City of Rohnert Park  
Public Works Department

DATE: SEPTEMBER 5, 2025  
TO: ALL PLANHOLDERS  
SUBJECT: CITY OF ROHNERT PARK  
BENICIA PARK CONCESSION STAND RENOVATION  
PROJECT  
NO. OF PAGES: 13

### ADDENDUM NO. 1

BENICIA PARK  
CONCESSION BUILDING  
FIRE REPLACEMENT  
7471 BERNICE AVENUE  
ROHNERT PARK, CA 94928

- CONTRACTOR SHALL VERIFY ALL DIMENSIONS & REQUIRED CLEARANCES W/ EQUIPMENT & COORDINATE W/ ARCHITECTURAL DETAILS PRIOR TO ORDERING & INSTALLATION.
- NOTIFY ARCHITECT IMMEDIATELY OF ANY DISCREPANCY IN THE FIELD

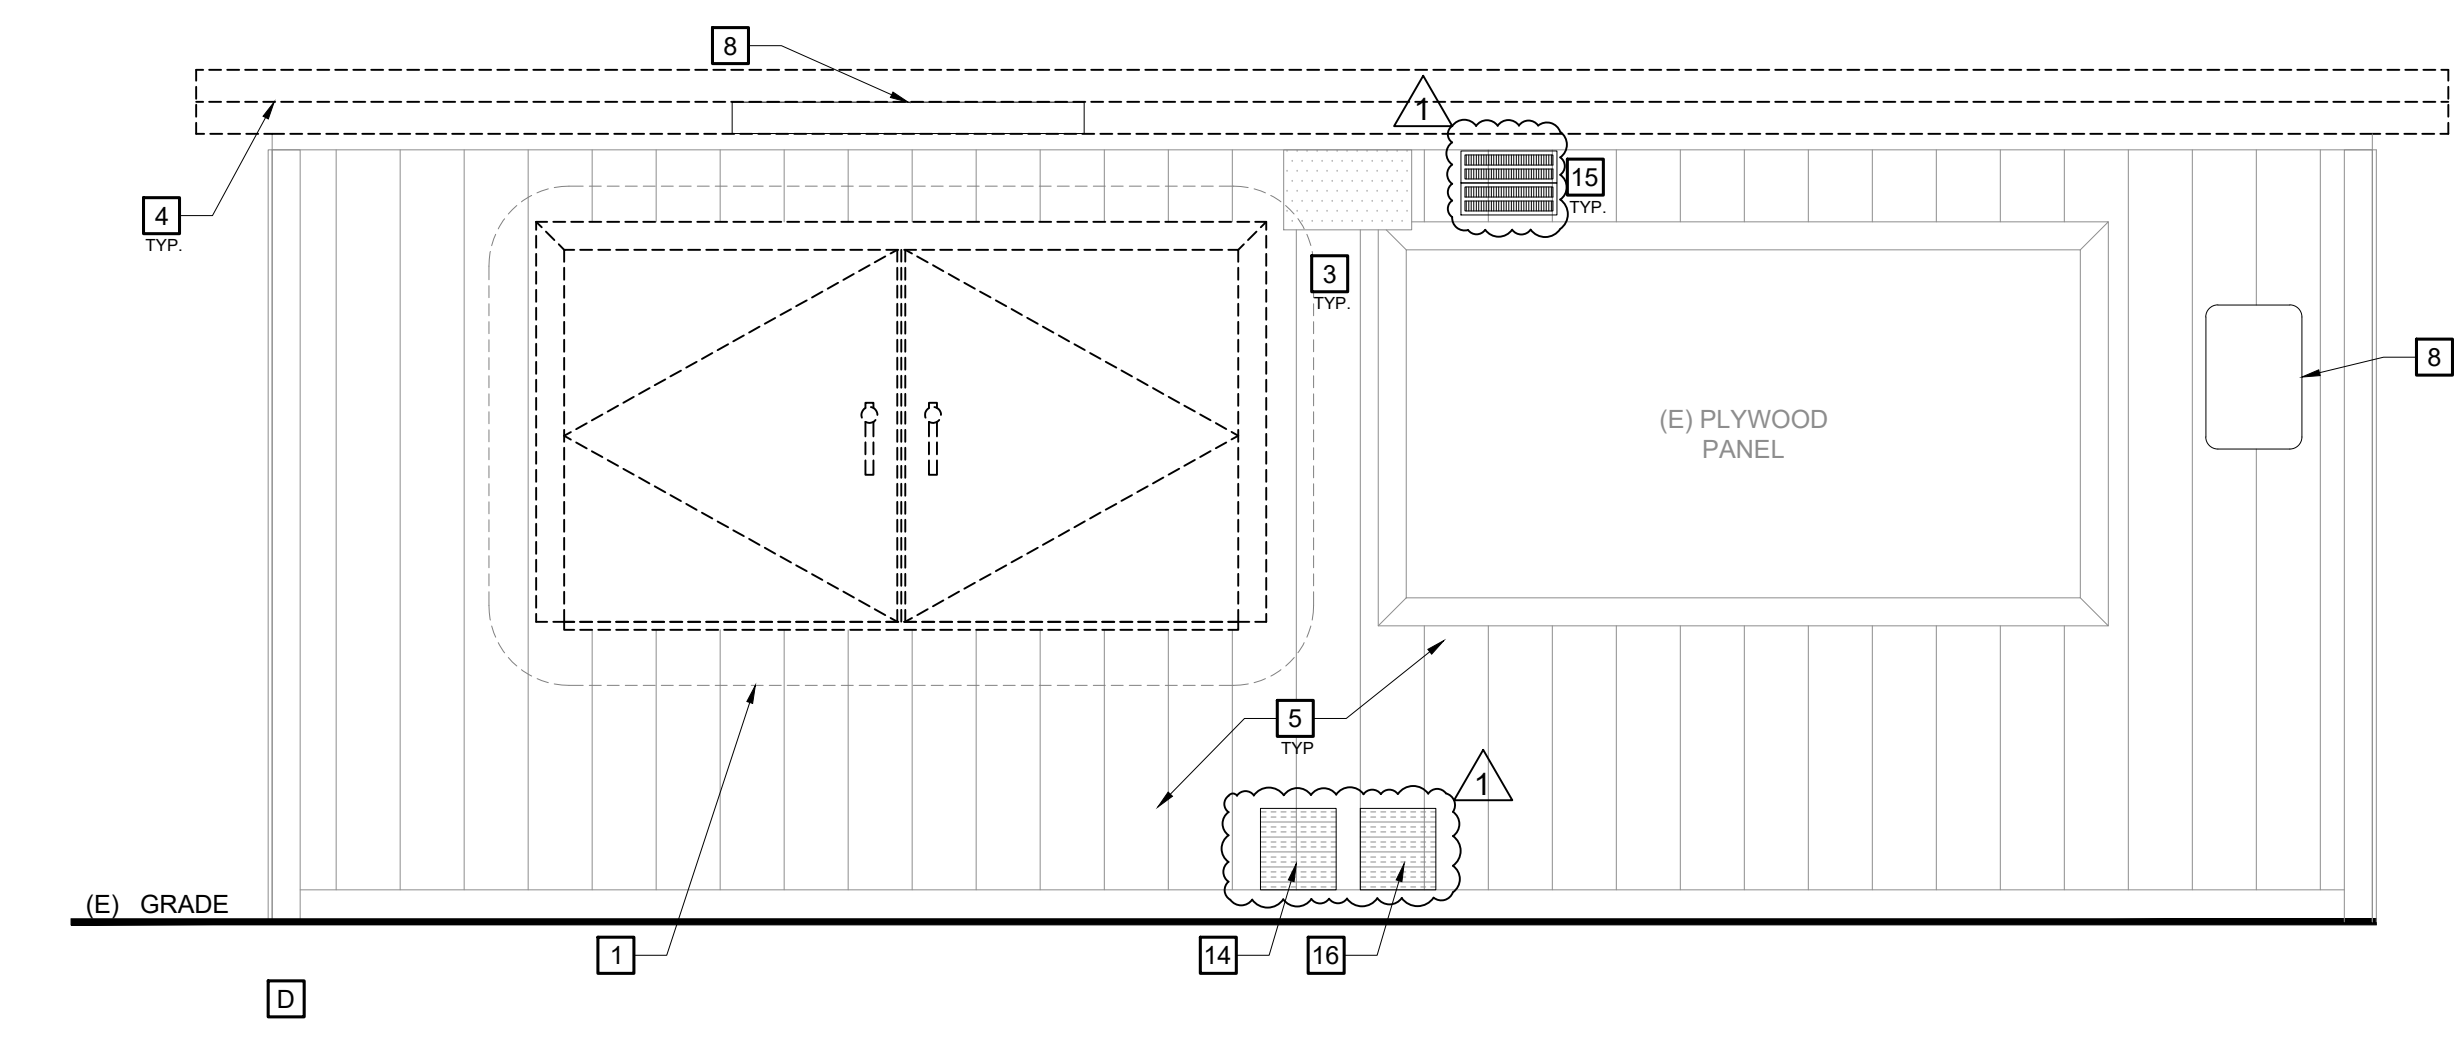
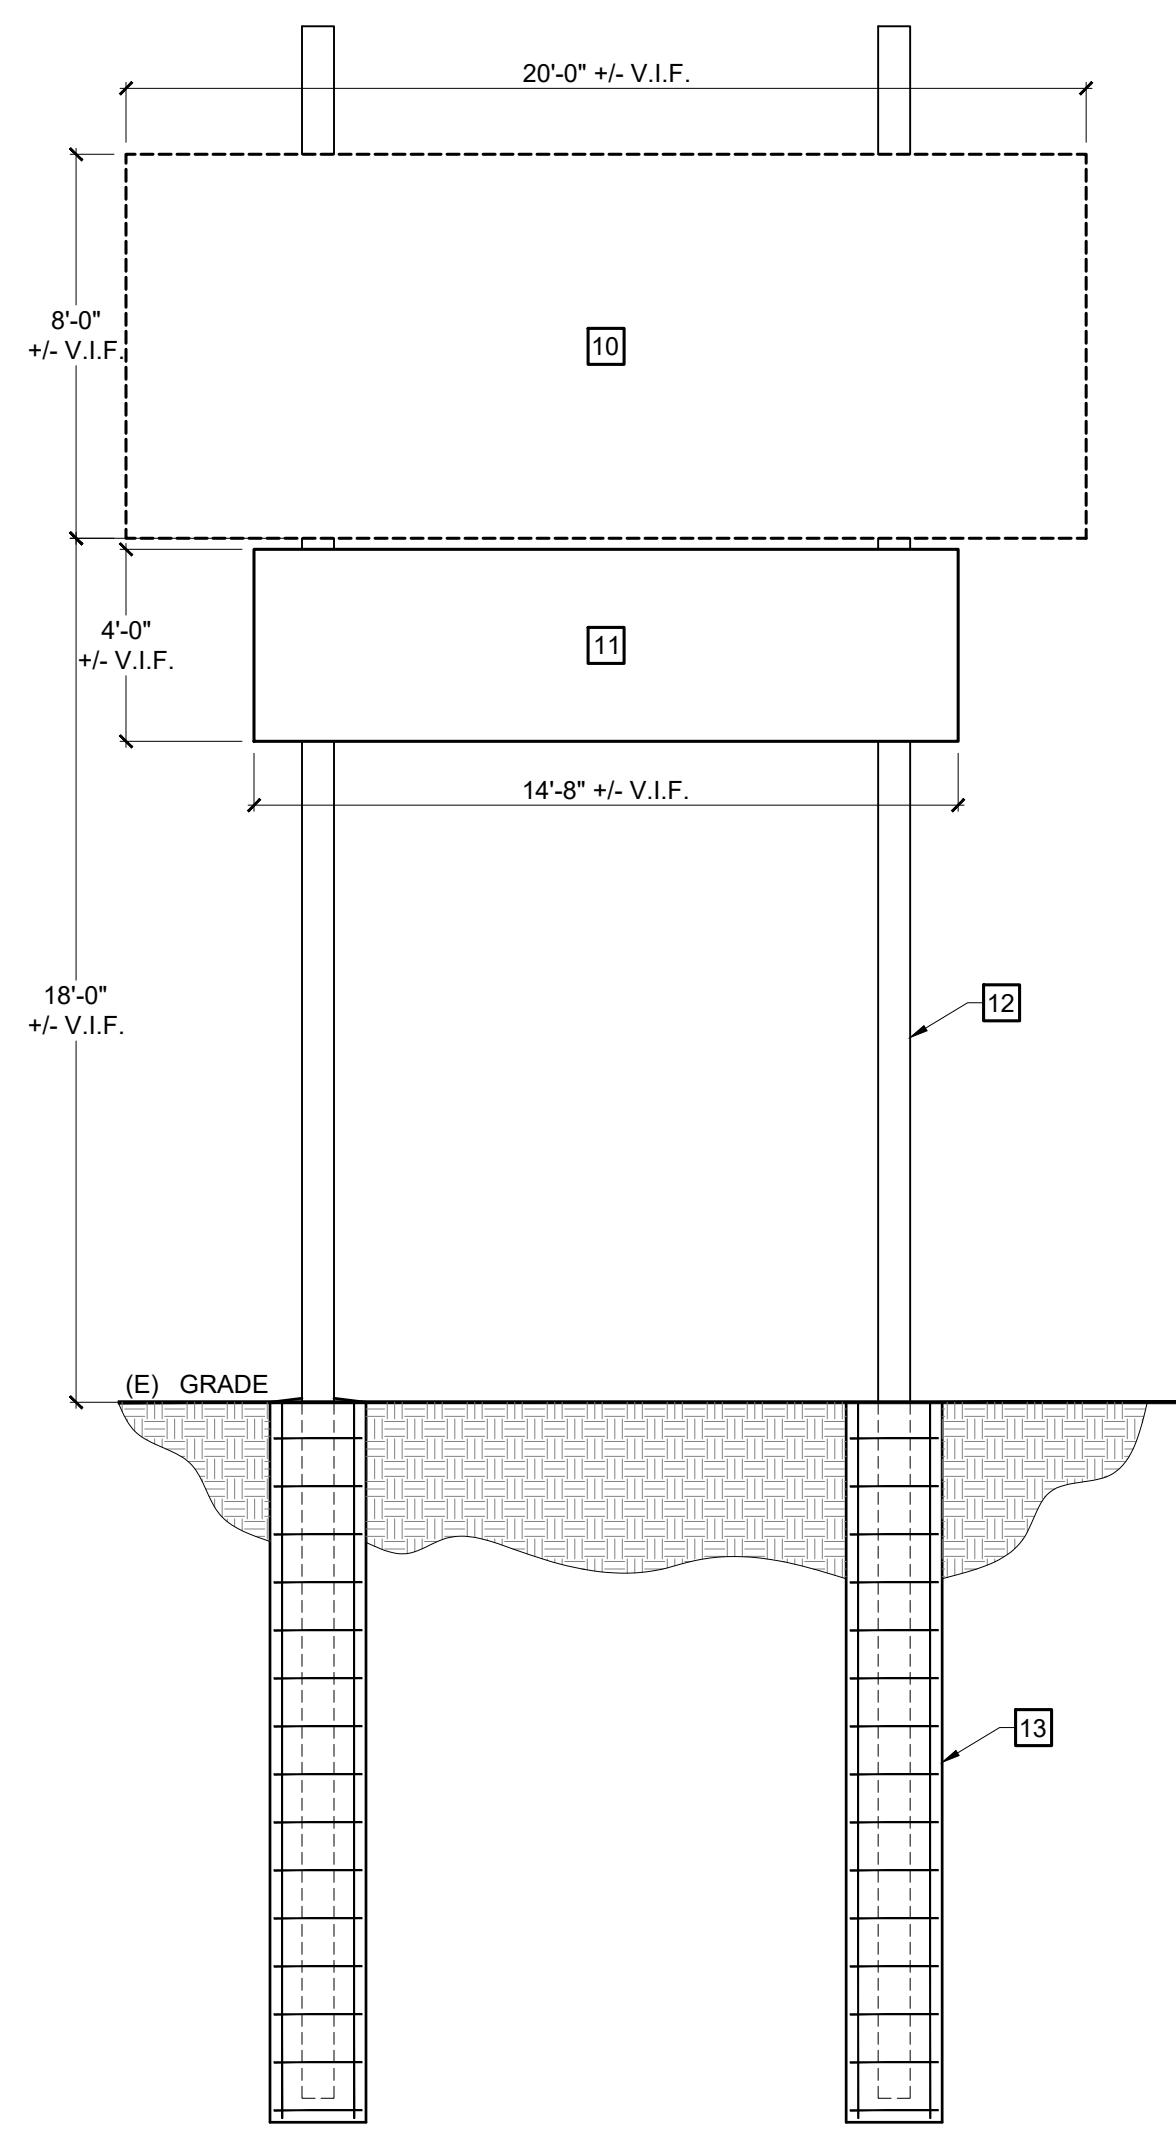
### **Sheet A3.00**

- Dry rot repairs
- Remove and replace fire damaged vent covers
- Remove metal plates and repair siding

**A3.01**

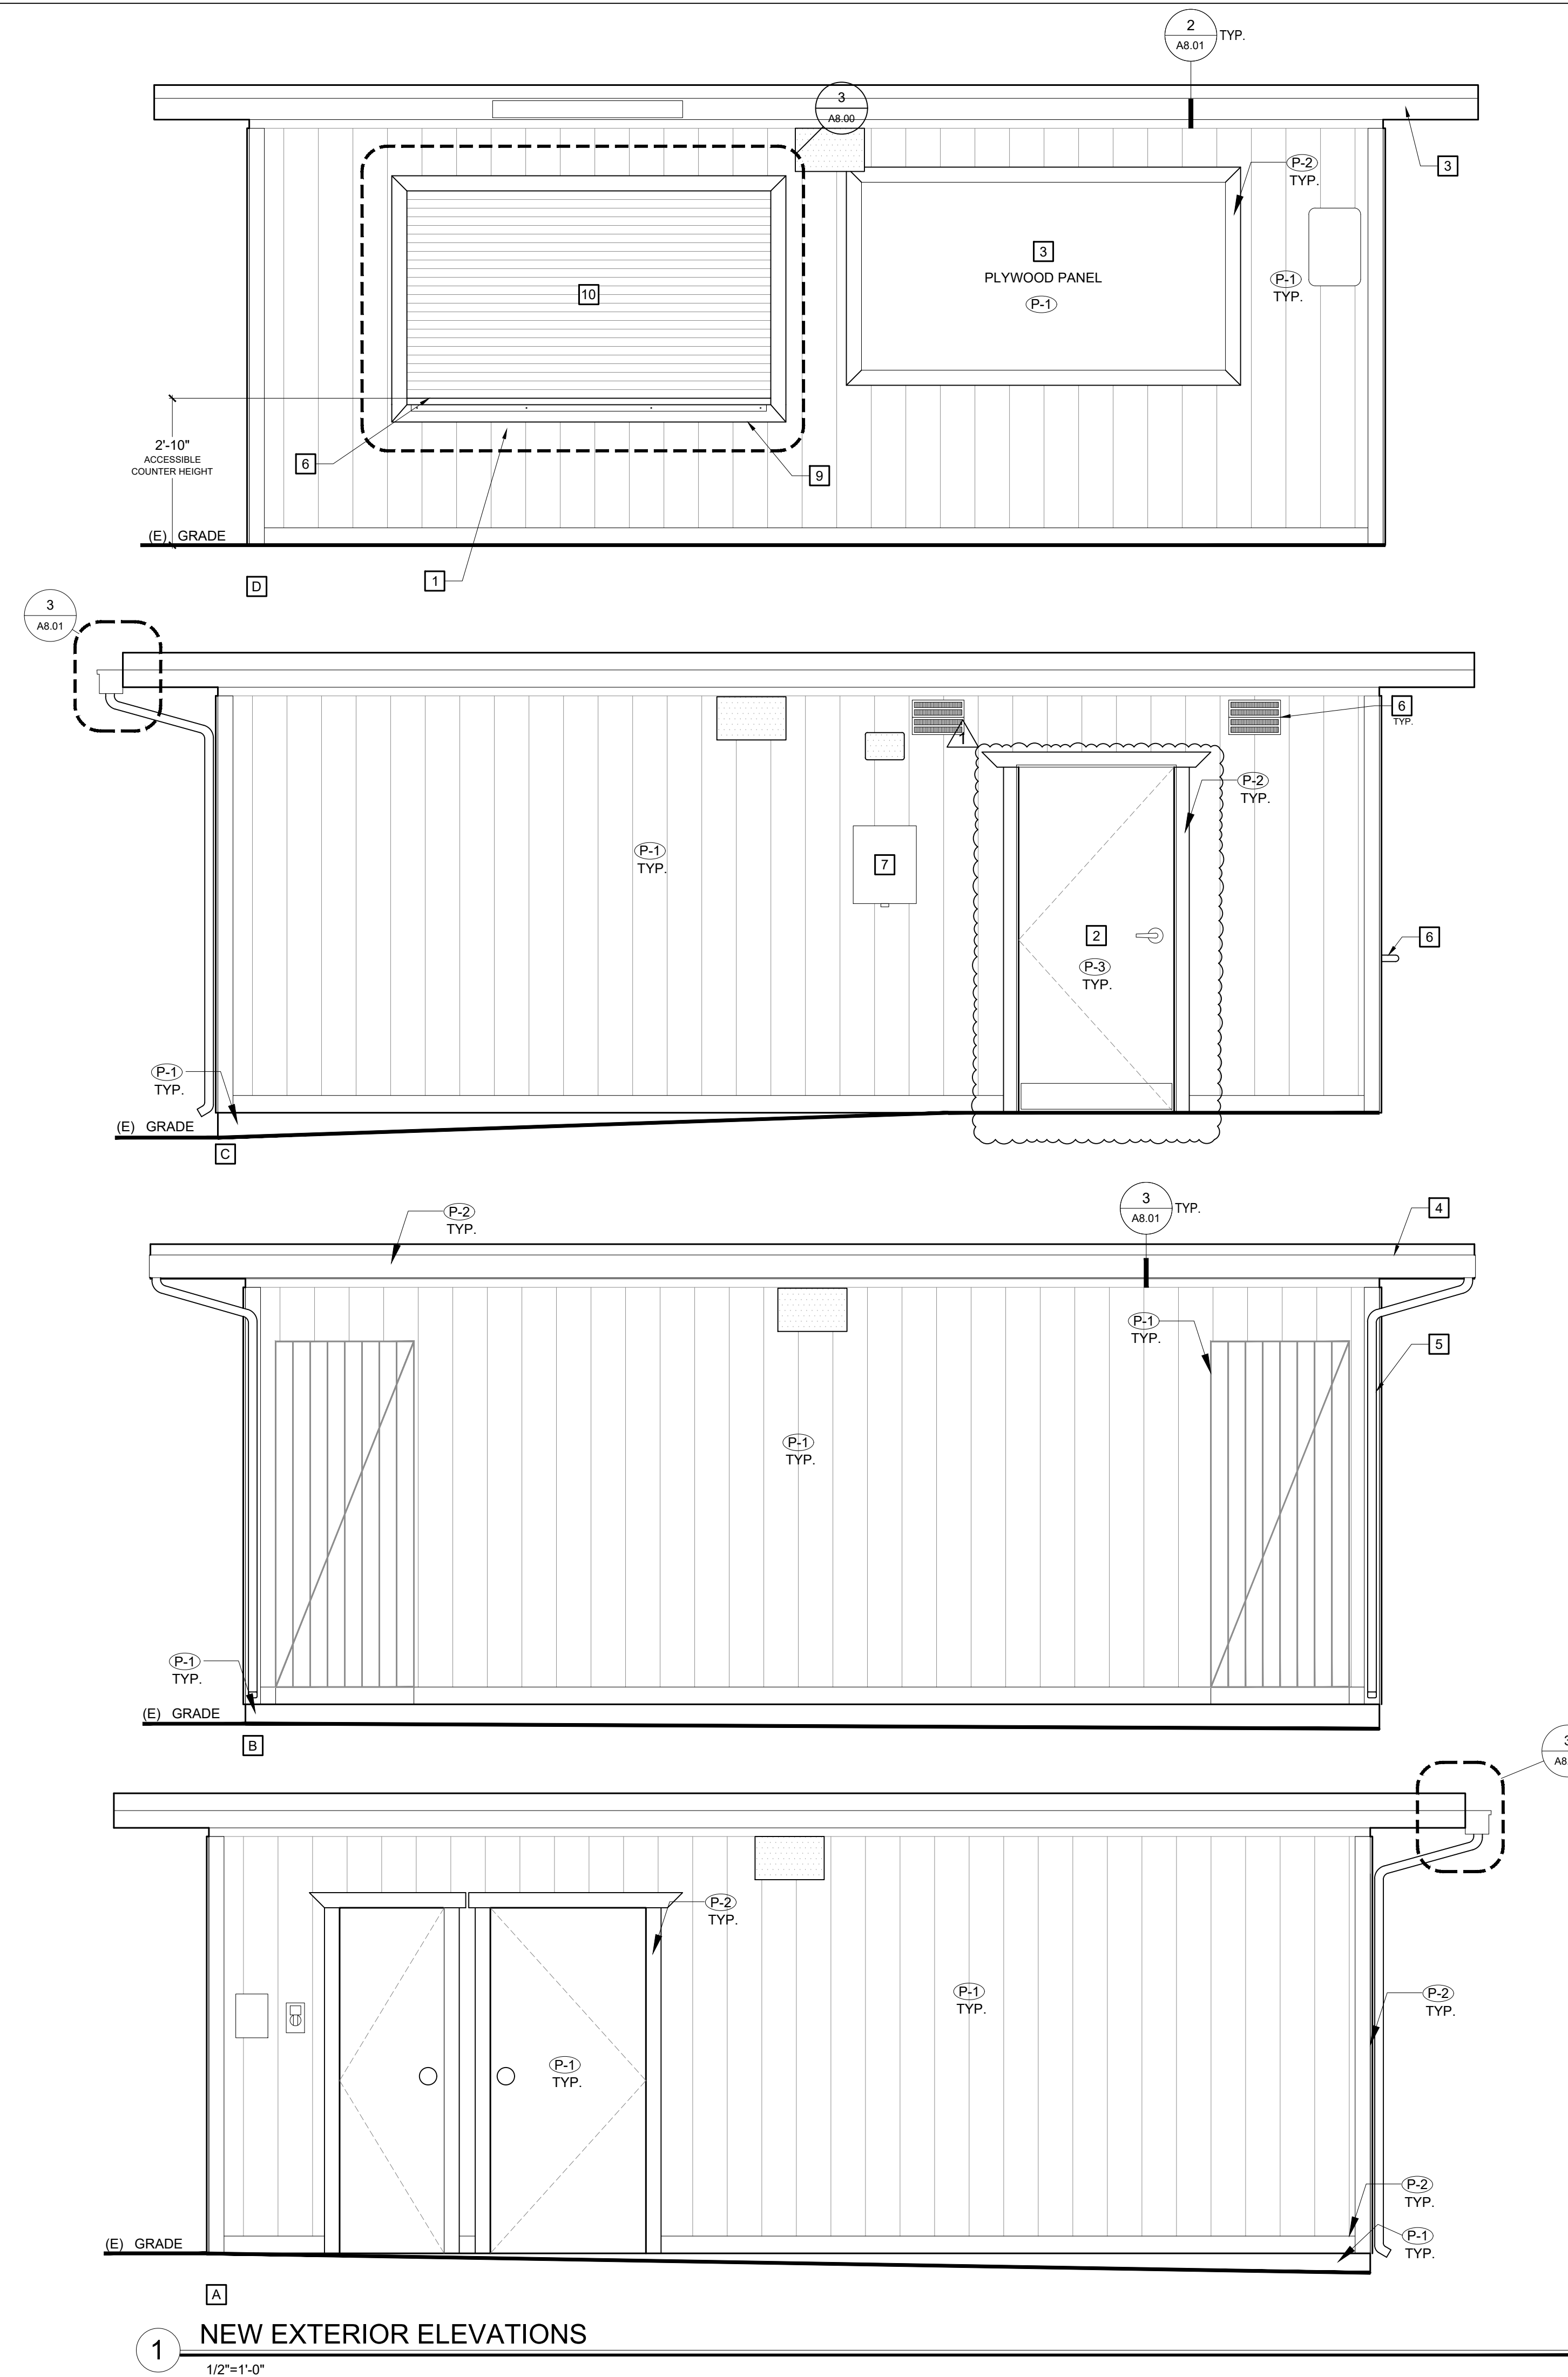
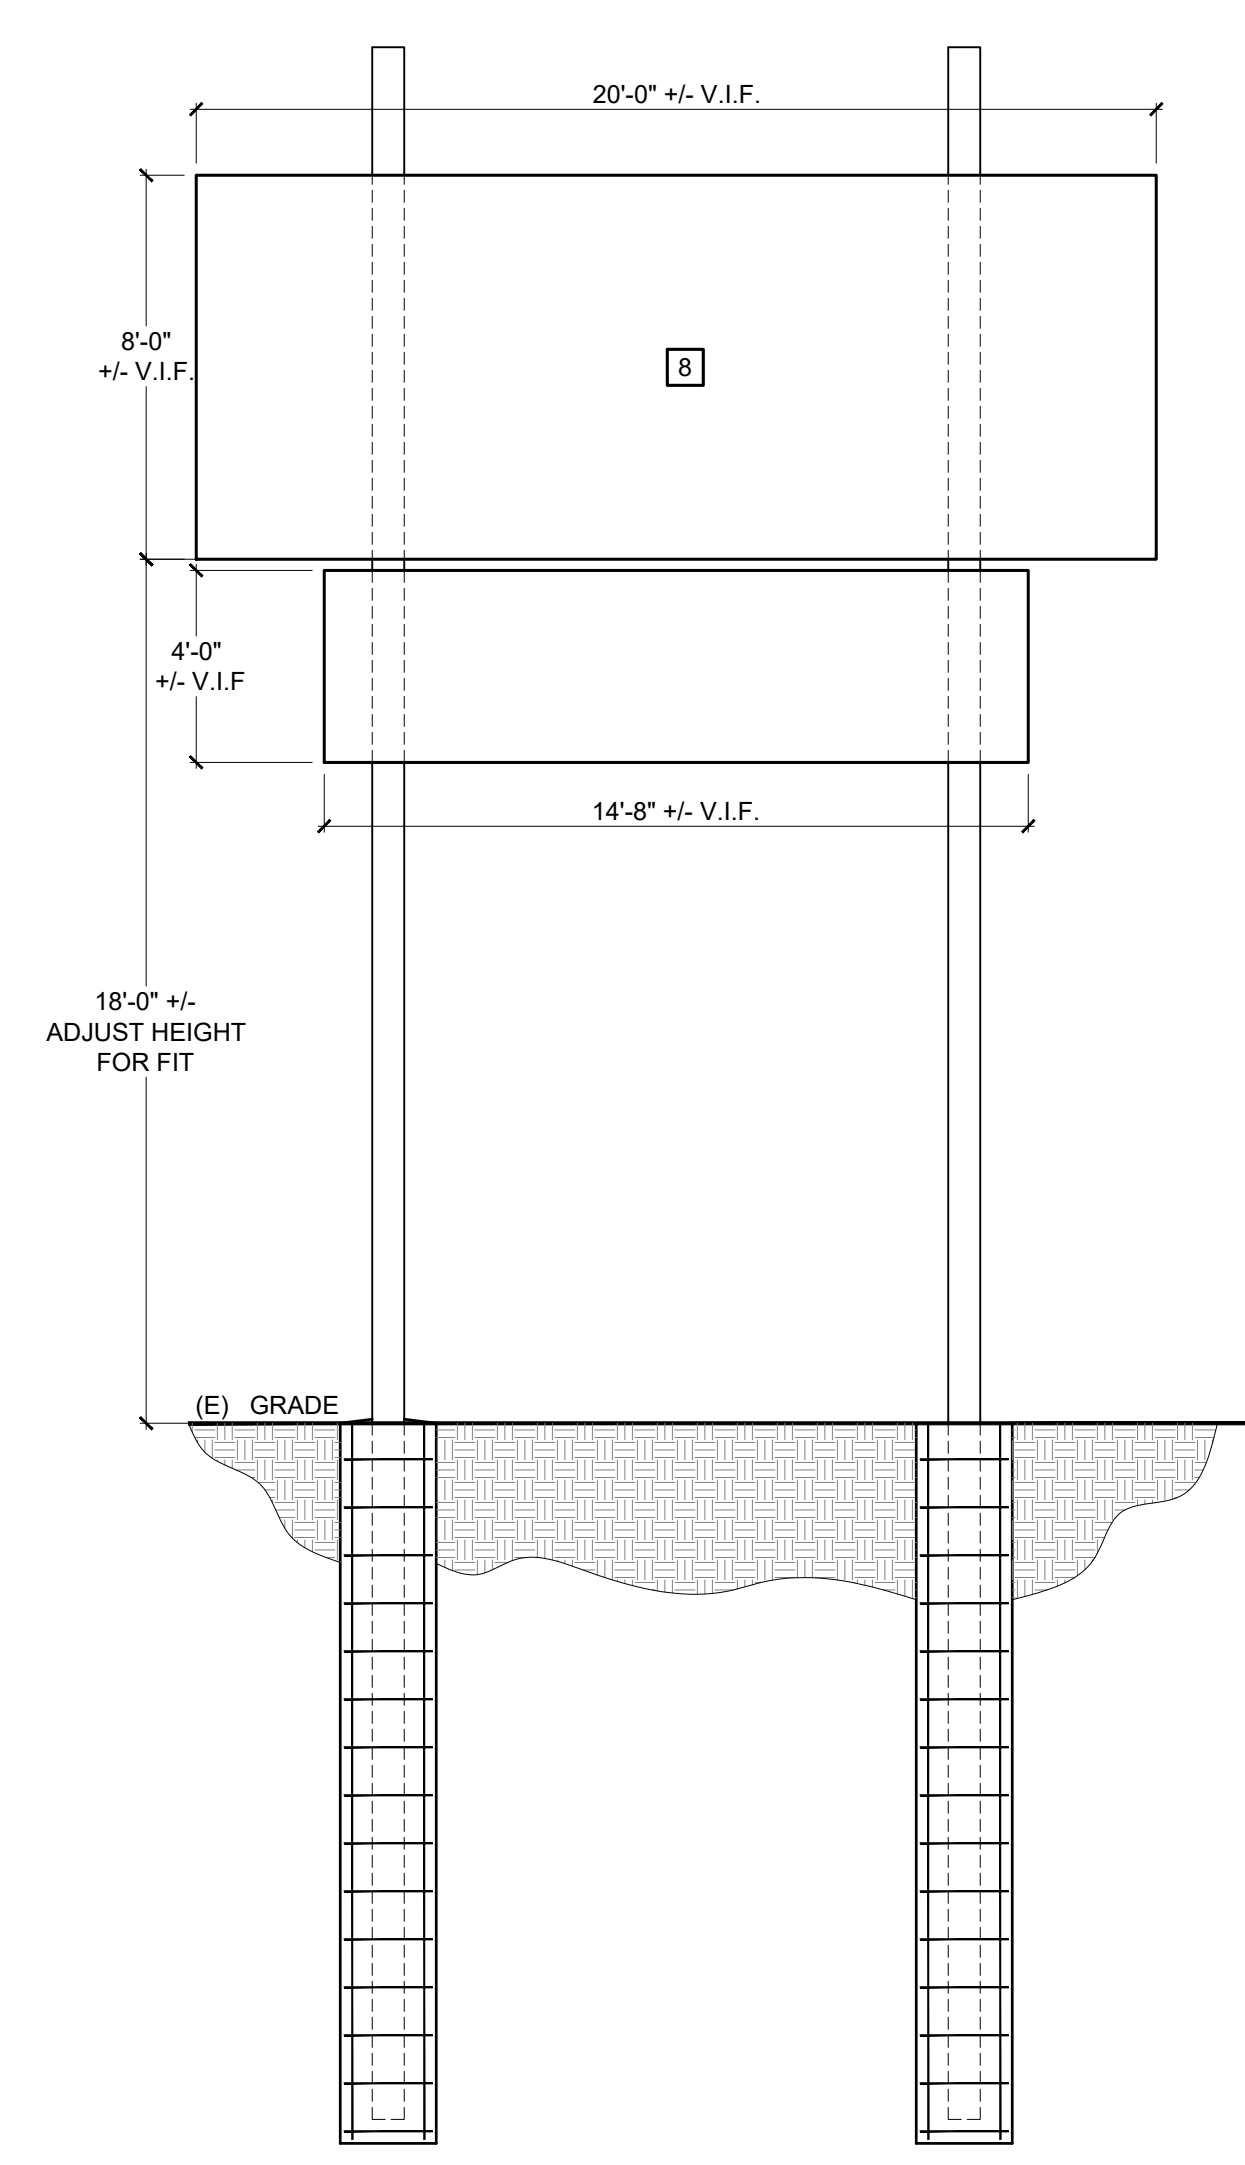
### **Sheet A3.01**

- Updated door hardware to reflect Push Rail and Lever Hardware
